BJM Consulting, Inc.

RE: ADD2019-00040: Explanation and Justification of Administrative Deviations for
Athenian –Three Oaks Charter School (Revised)

Exhibit #1

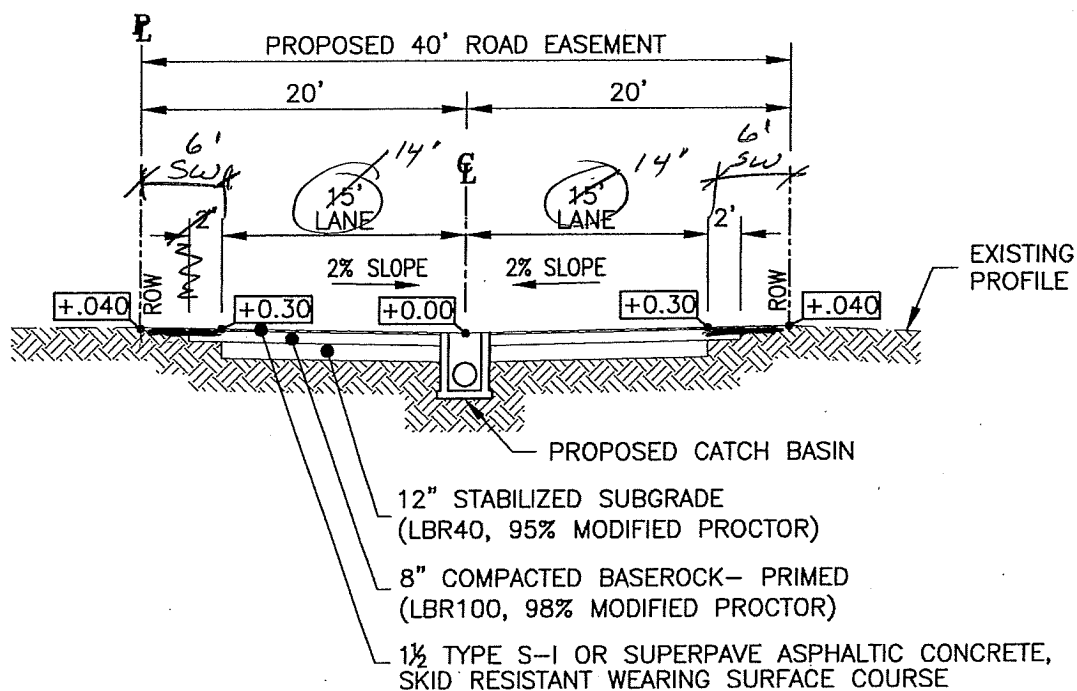
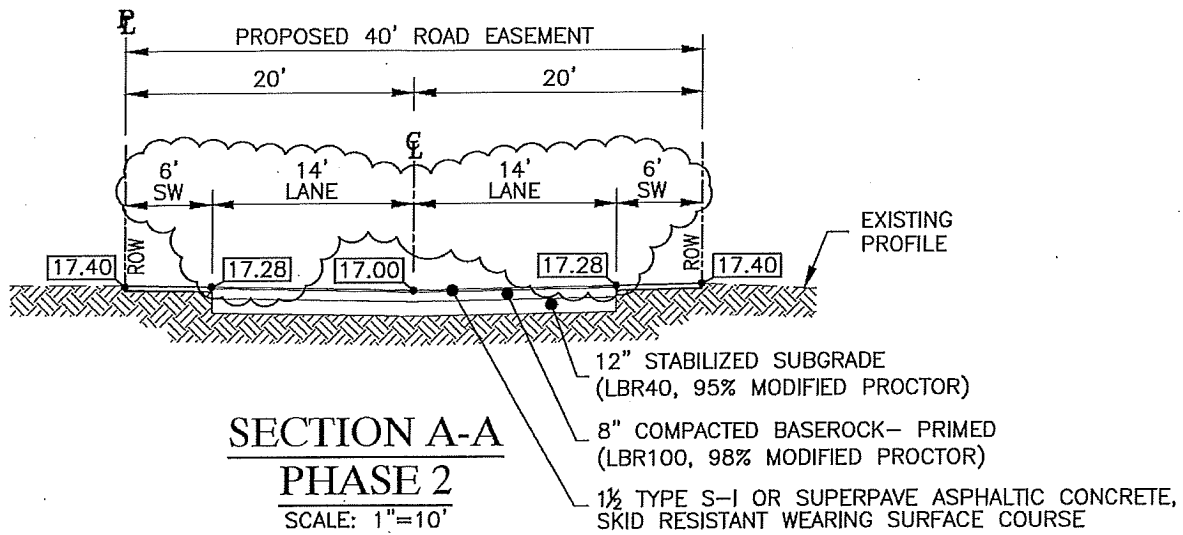
- ① Deviation from 10-296(d)(4) (Drainage-Inverted crown) see attached inverted street section sketch Exhibit #1 – provides an alternate closed drainage cross section providing 30' pavement width within a 40' R/W, to match the previously constructed street and stub-out. This deviation is required to meet the existing private road cross
- 28'

- ③ Deviation from 10-296(e) (cross-section) see attached inverted street section sketch Exhibit #1 – provides an alternate closed drainage cross section providing 30' pavement width within a 40' R/W, to match the previously constructed street and stub-out. This deviation is required to meet the existing private road cross section and provide a reasonable safe continuation to the cars that will be traveling along this private road extension.

Not
Correct

The requested deviation is specifically from the Lee County LDC Sec 10-296. The deviation is to allow for an inverted crown road cross section rather than the standard crowned section depicted in the details included in the LDC Sec 10-296. It is the intent of this alternate street cross section to also follow the standards and criteria established by FDOT in the Florida Greenbook with consideration of the Plans Preparation Manual and guidance in AASHTO publications. It should be noted that FDOT standards have been created primarily for the use in public highway design and not for "private local"

streets, however we have found nothing in the referenced publications that specifically precludes the use of an "inverted" crown road cross section. Those referenced standards do include a minimum cross slope of 0.02 feet per foot, which has been included in the proposed "inverted" crown road cross section.

Exhibit #2

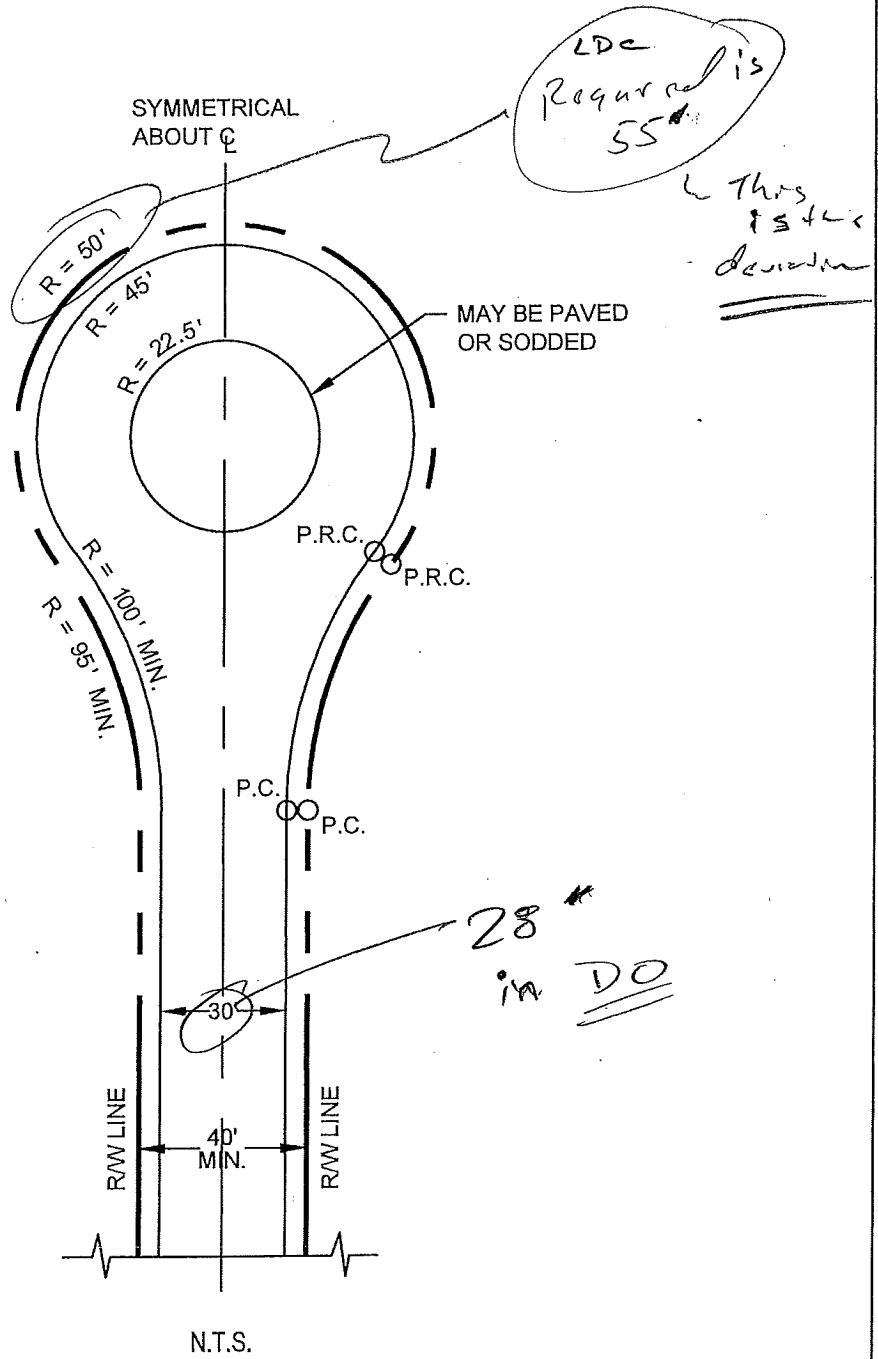
Radius as Referenced
From the Center of the
Cul-de-sac → 50' instead
of 55'

- ② Deviation from 10-296(k)(1) (b & c)(cul-de-sac ROW) see attached cul-de-sac inverted crown Exhibit #2 – provides for the same dimension from the edge of pavement to the RAW-line as is provided in the 30' pavement width within a 40' R/W cross section while maintaining the standard cul-de-sac pavement dimensions. This deviation is required to meet the existing private road cross section and provide a reasonable safe continuation to the cars that will be traveling along this private road extension.

Exhibit #3

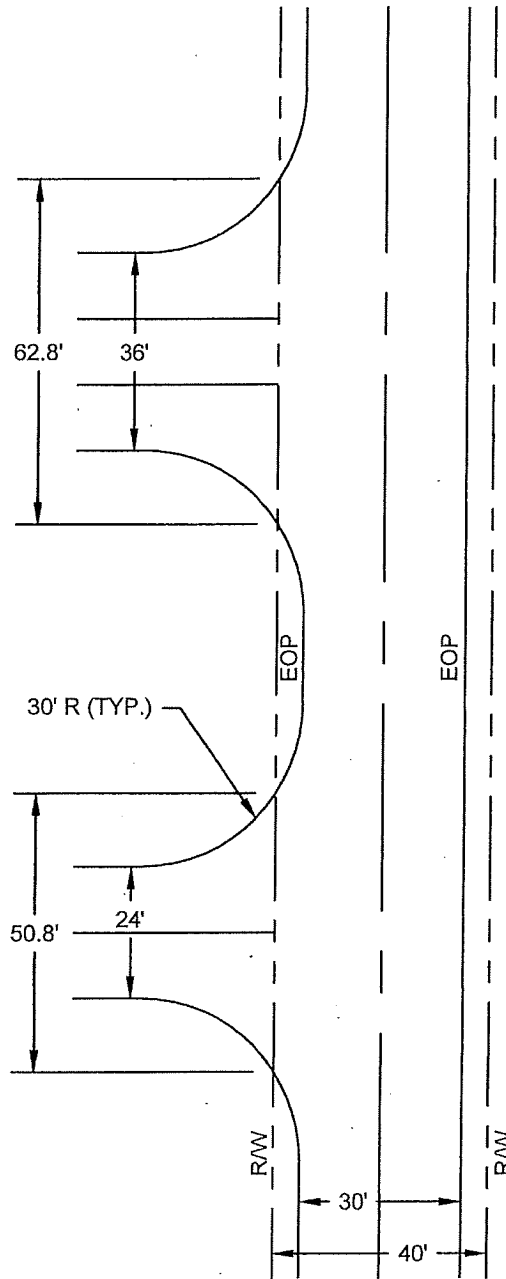
- ⑤ Deviation from 34-2013(b)(3) (parking lot entrance maximum width of 35' at property line) See attached parking entrance sketch Exhibit #3. – Note that this deviation is necessary due in part that the R/W offset to pavement is only 5' and even with a 24' wide two lane entrance connecting to the street with a 30' radius, the width of pavement at the R/W would be over 50' wide (a 36' wide three lane entrance would be over 62' wide). The alternative design meets the specific needs to the proposed use of a charter school.
